Challenging Behaviour Unit ST Helena: Technical Review of Proposals

Roger Lewis, TKL Architects LLP

January 2014

Figure 5: Bathroom for independent use incorporating a corner WC layout

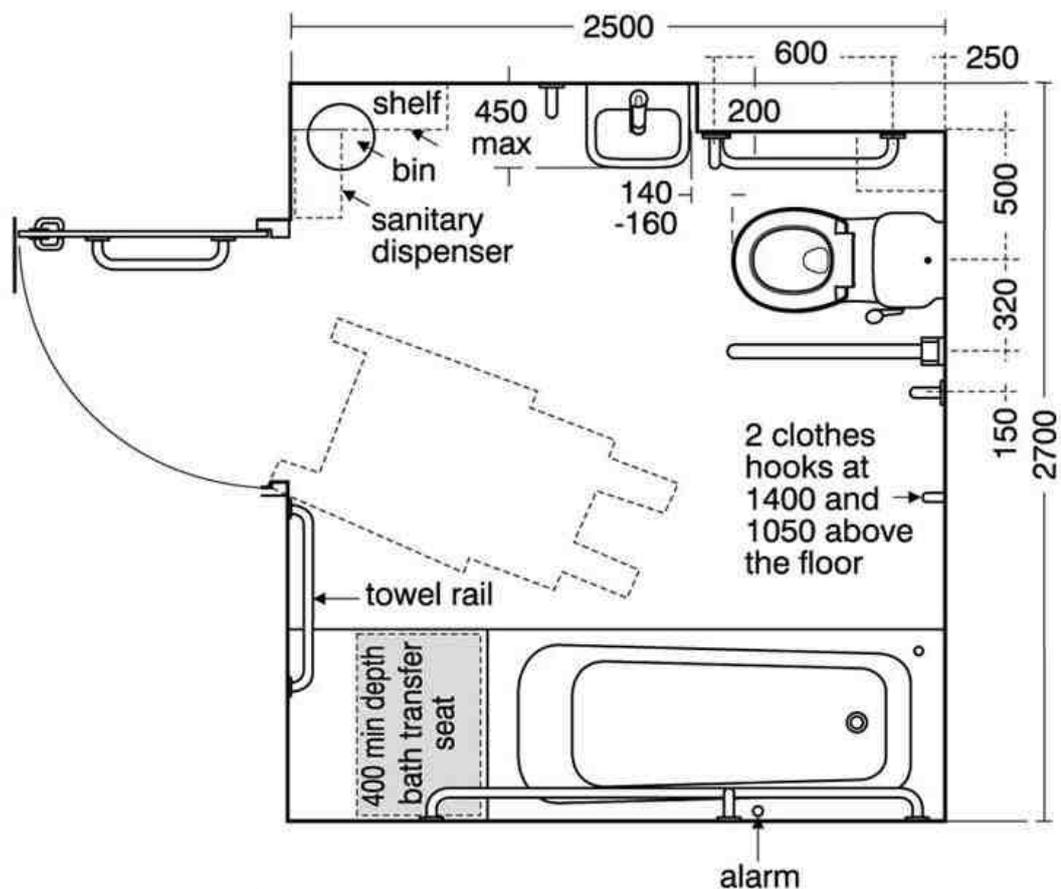
- 2.3.9 Outline requirements for ensuite showers and bathrooms are described in the Specification and Room Data Sheets appended to it. Sizes of rooms are adequate, but accessibility of the ensuite showers would be improved by changing the swing of the doors to the opposite hand. The layout of the ensuite showers is shown on the plans but no layout is given for the bathrooms. Reference is made to a website for suggested design details (www.disabledtoilets.co.uk) which does have some useful information, although this is a commercial company selling a variety of sanitary products suitable for a wide range of disabilities. A better guide for design principles would be Diagram 25 of Building Regulations Approved Document M (Figure 2).

Figure 6: Shower room for independent use incorporating a corner WC layout

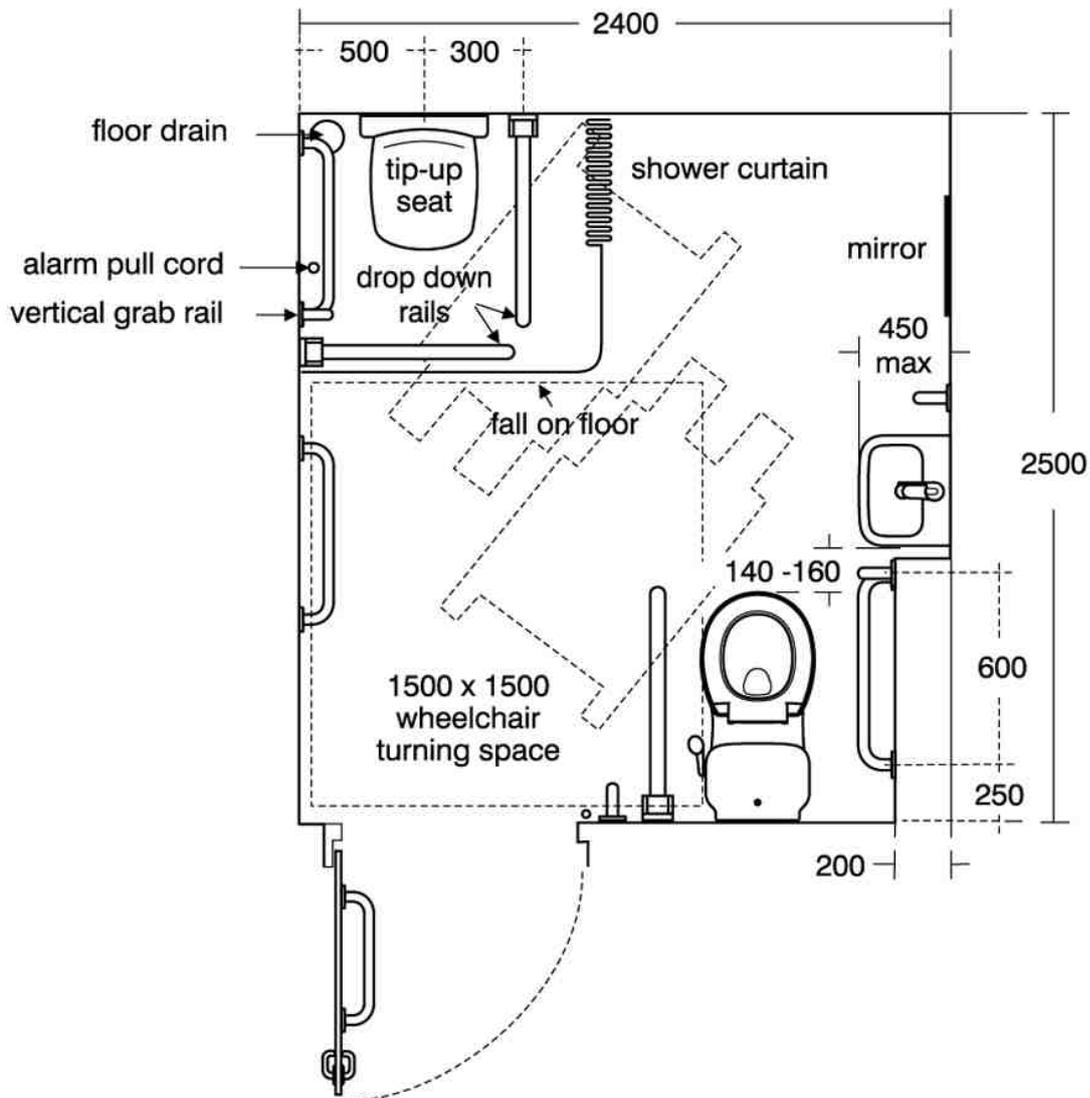
Baths may not be suited to some residents with particular mobility problems so consideration could be given to providing a shower instead of a bath in one of the two bathrooms (see Figure 3).

Figure 10: Ex Avec building layout – 17/004/2013

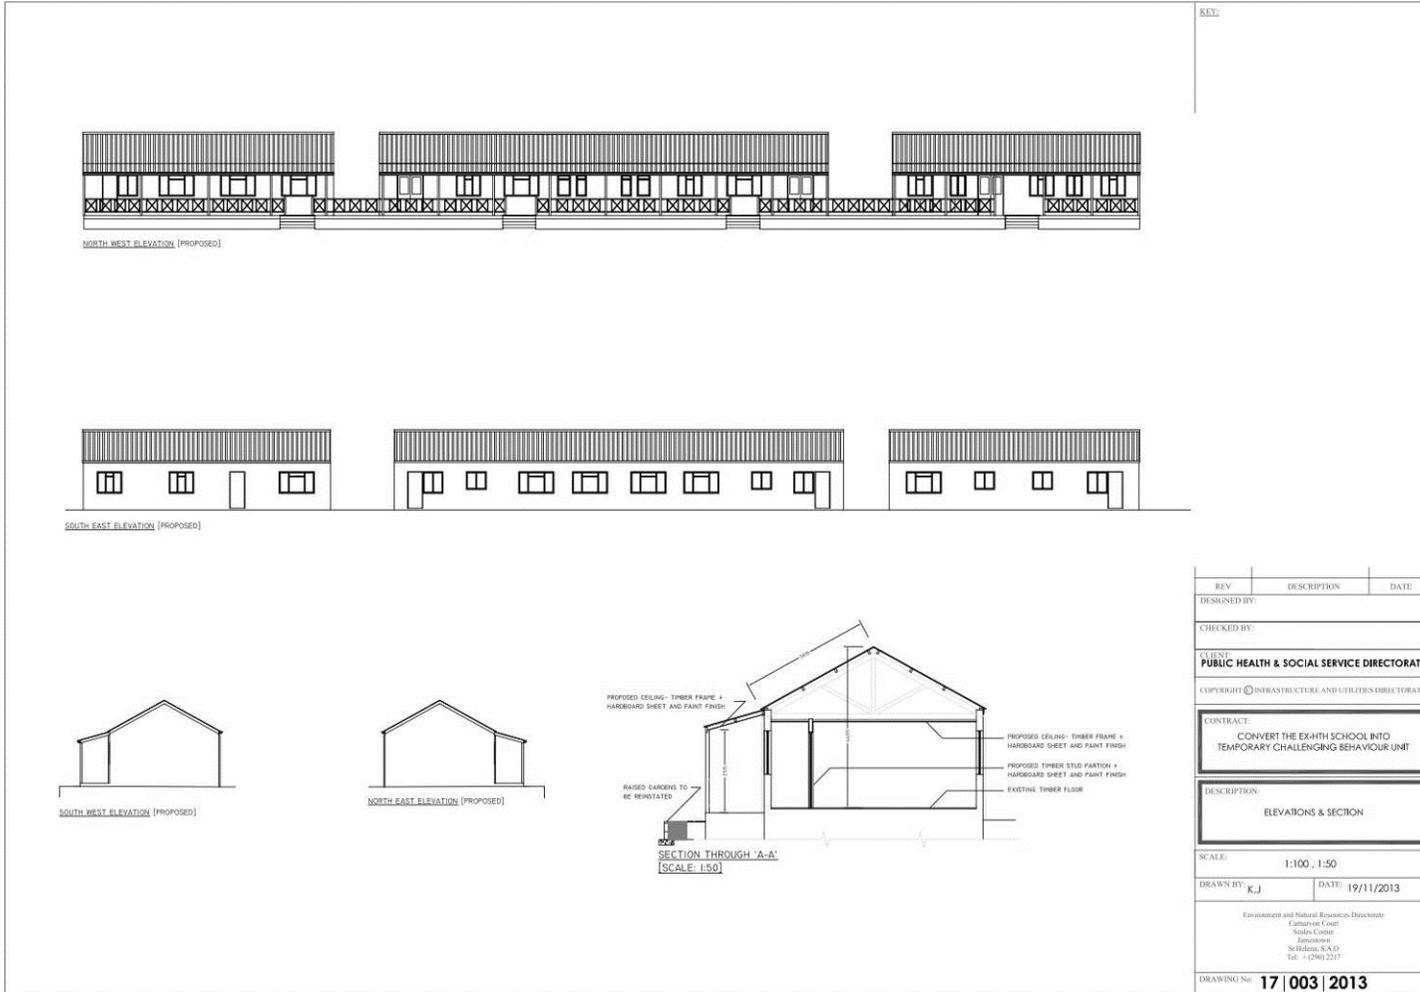
2.4.4 Specification of construction, fixtures, fittings and services is generally similar to that in the main buildings. However, there are a number of anomalies on drawing no. 17/004/2013.

- It is noted that the Services plan shows a different use of certain rooms from that on the general layout plan – the Office has become a Meeting Room and the Sensory Room an Office.
- The Services plan shows no light fittings in the Reception Office or Meeting Room, and no telephone point or smoke detector in the Office.
- The new small window to the Disabled Toilet is shown on the rear elevation but not on the plans.
- There is no window provided to the Office / Meeting Room, hence this room would have no natural light or ventilation.

It may be this is indicative of work in progress but clarification and confirmation should be provided before the project moves forward.
